AFFIDAVIT

Planning and Environment Court

David Manteit V Brisbane City Council 2916/24

AFFIDAVIT - Response to Corrigan report

Corrigan option 2 , corrected by Manteit

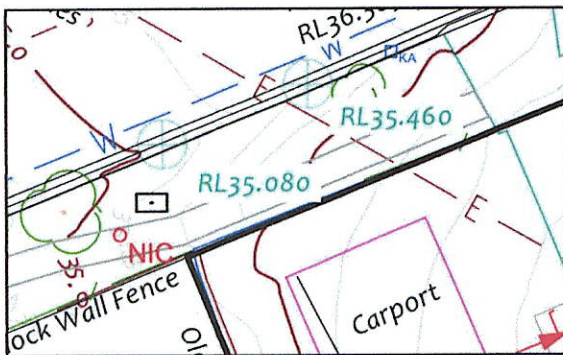
82. There is no requirement by Manteit to change the levels of the land. Corrigan proposed to flood the site, with a charged pipe, in the same way as the original illegal red line with no RPEQ certification. Who would have thought another flooded pipe. This time by an RPEQ, certified.

Corrigan system 2								
	Stub 97	Stub 98	Stub 99	Pit 4	Pit 5	Pit 6	Kerb	Cross check
FSL	37.300	37.000	36.000	36.000	35.798	35.500	35.300	
Pipe Length		20000	20000	6000	11000	8000	8000	73000 mm
New start of line invert level brought forward		36.625	36.325	35.250	35.220	35.048	34.750	36.625 m
Min .5% fall, 1% over verge		0.100	0.100	0.030	0.055	0.040	0.080	-0.405 m
Invert level end of line.	36.625	36.525	36.225	35.220	35.165	35.008	34.670	m
Prima facie depth (needs to be min 675)	0.675	0.475	-0.225	0.780	0.633	0.492	0.630	m
Pipe needs to be lowered by to make it work.		0.200	0.975	0.000	0.117	0.258	0.000	-1.550 m
Adopted pit level		36.325	35.250	35.220	35.048	34.750	34.670	34.670 m
Lawful point of discharge							35.460	
Corrigan charged system malfunction in metres							-0.790	m

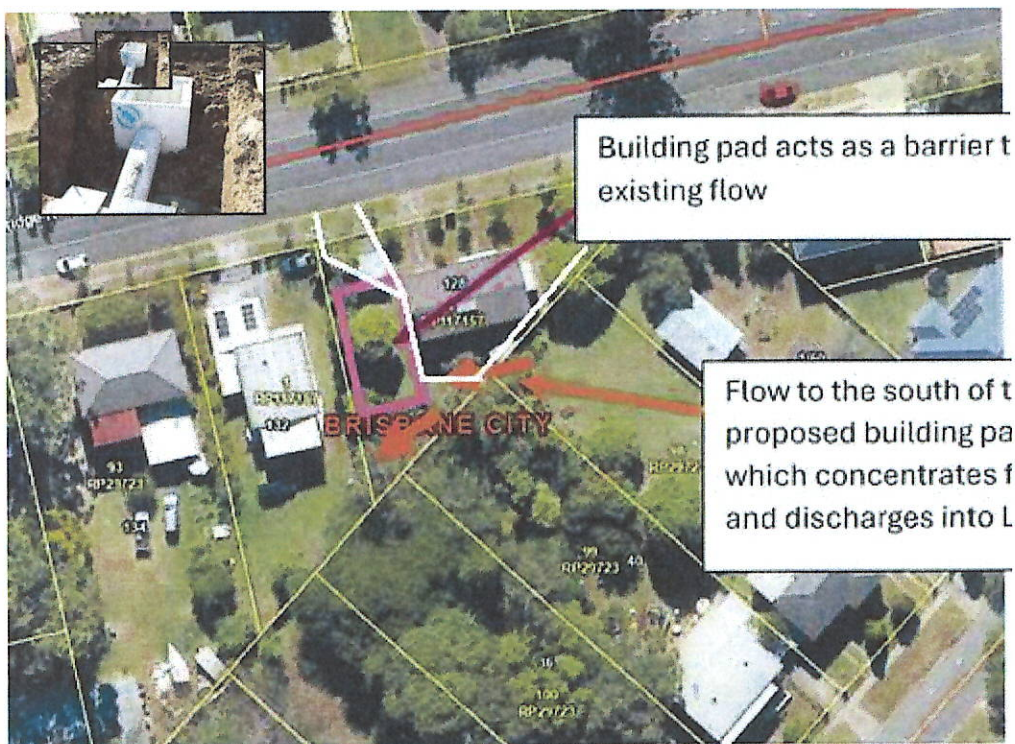
83 Corrigan plan to cause the demolition of the existing house.

84. Pipe between Lot 97 and Lot 98 will travel within 700mm of back fire escape steps. Hence part of the house would need to be demolished.

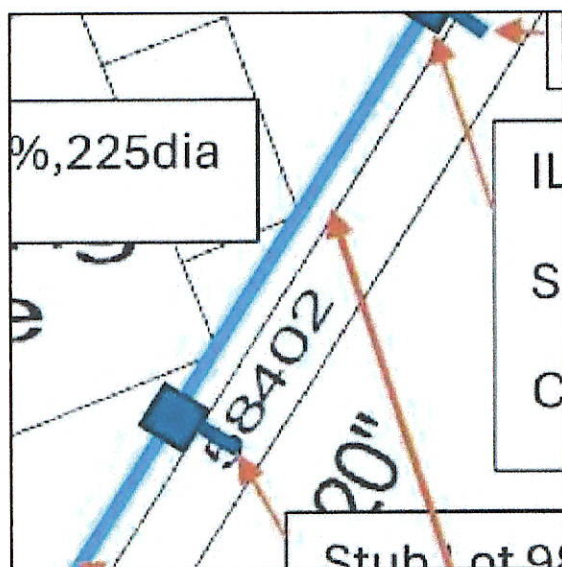
85. In addition, It is not possible to place a concrete pit 600mm to centre, and have sufficient drainage gravel.

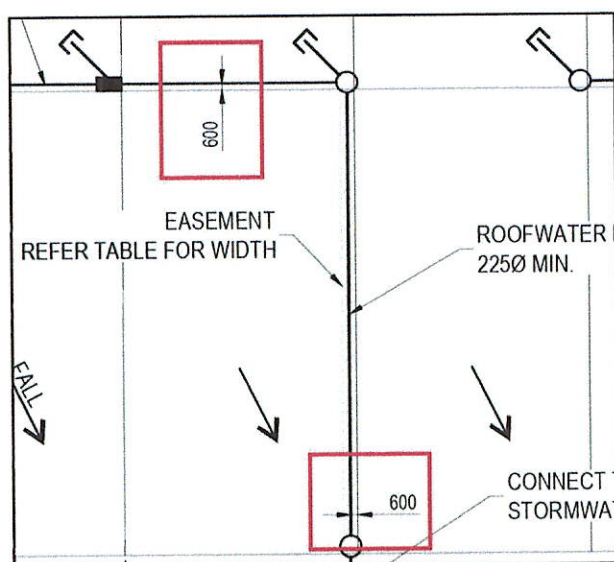
90. Upstream pipe would conflict with the future and current house rainwater pipes, 150 cover, 450 depth, connecting to the proper lawful point of discharge.

91. Would need a concrete manhole 900mm wide to cater for the depth of the pipe between the house and the Boundary fence.

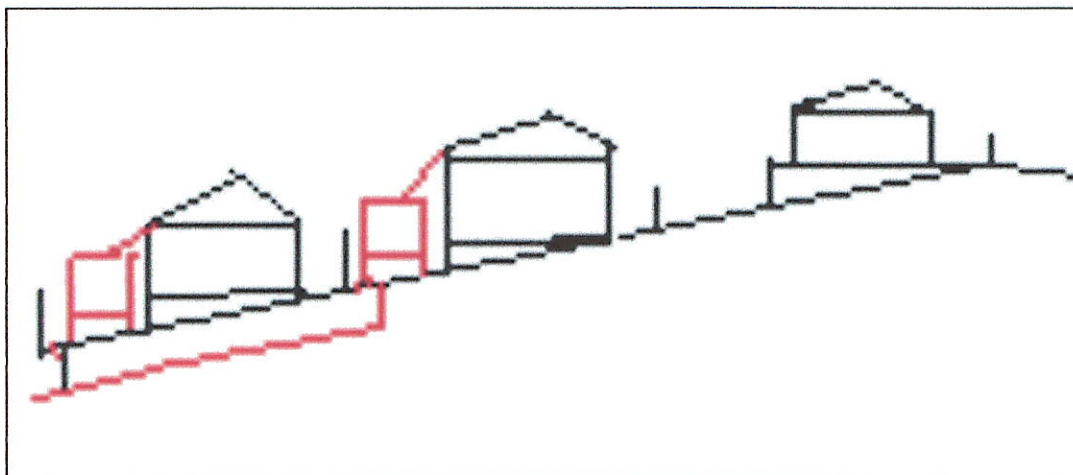
It is unsure how Corrigan can get 71.3 litres per second into 2 kerb adaptors of 30 litres capacity.

Corrigan has water tanks for 75 - 28 litres per second = 47 litres per second = 169,200 litres per hour, as per fraction impervious. This is 17 * 10,000 litre water tanks required. That's 6 water tanks required per property. 5 square metres per tank = 30 square metres gone in your backyard.

133. Corrigan 169,000 l/s per hour (who knows) rainwater tank plan

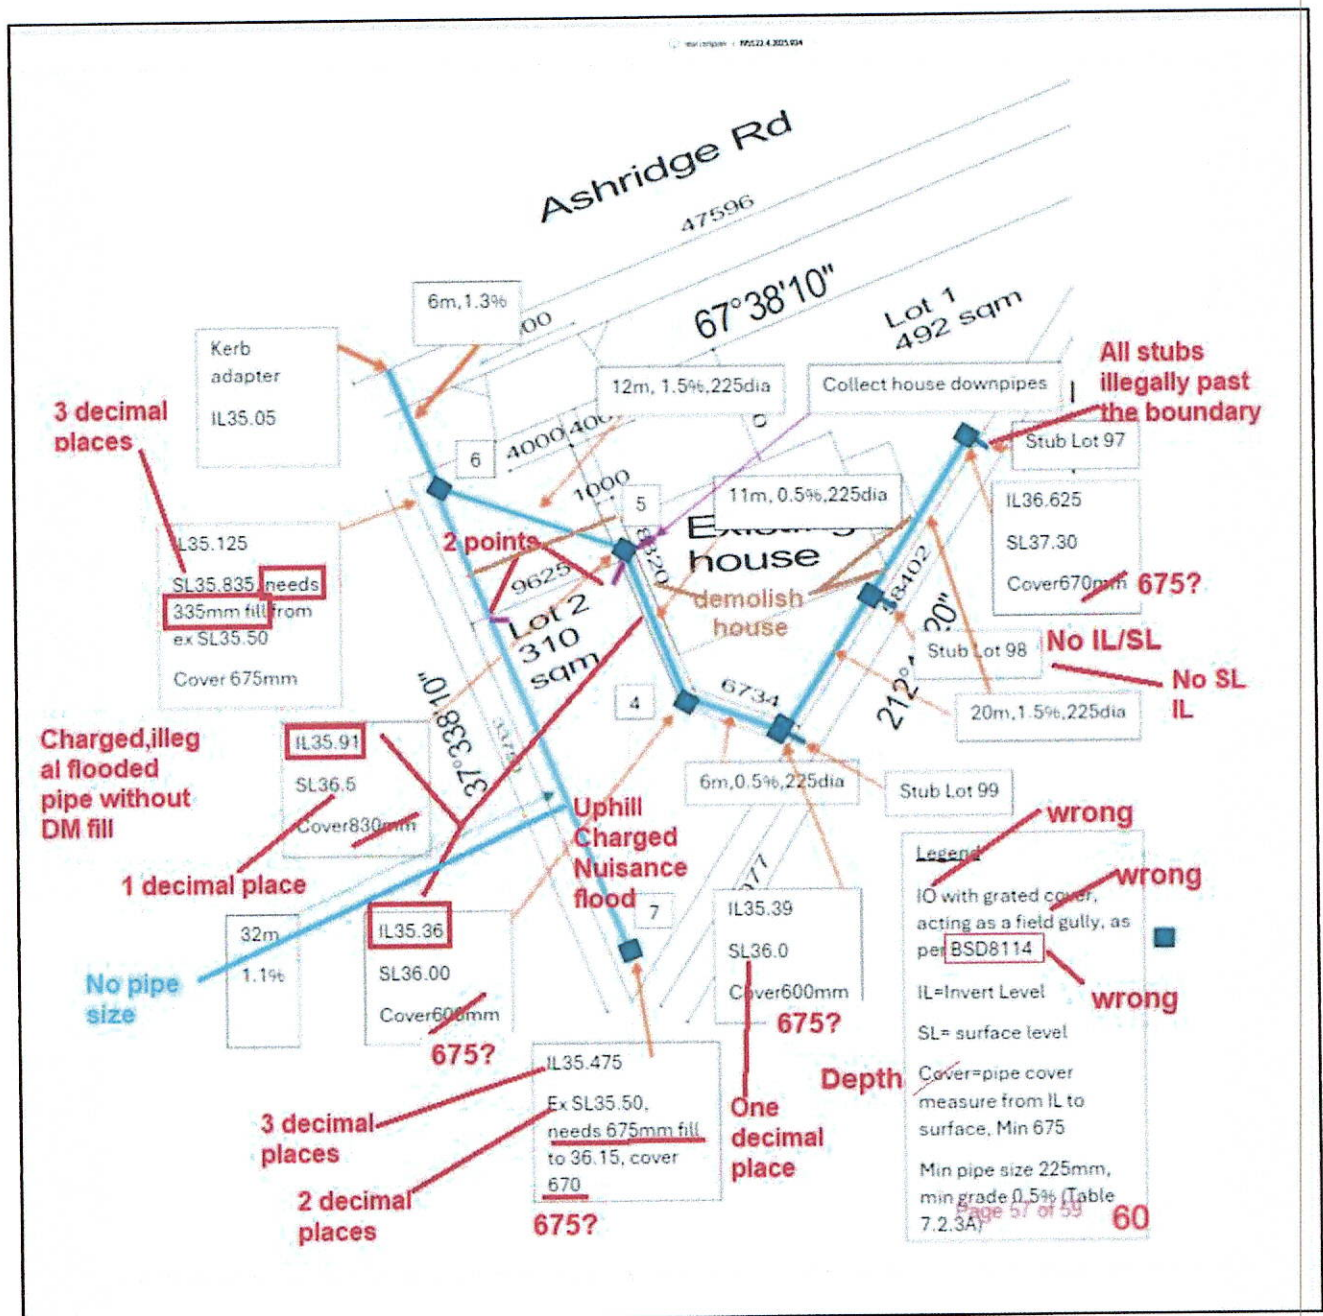
134. No detention pits drawn by Corrigan? Why not ?

135. Above - depiction of 16 water tanks that will provide water protection for one hour, when the expected rainfall comes.
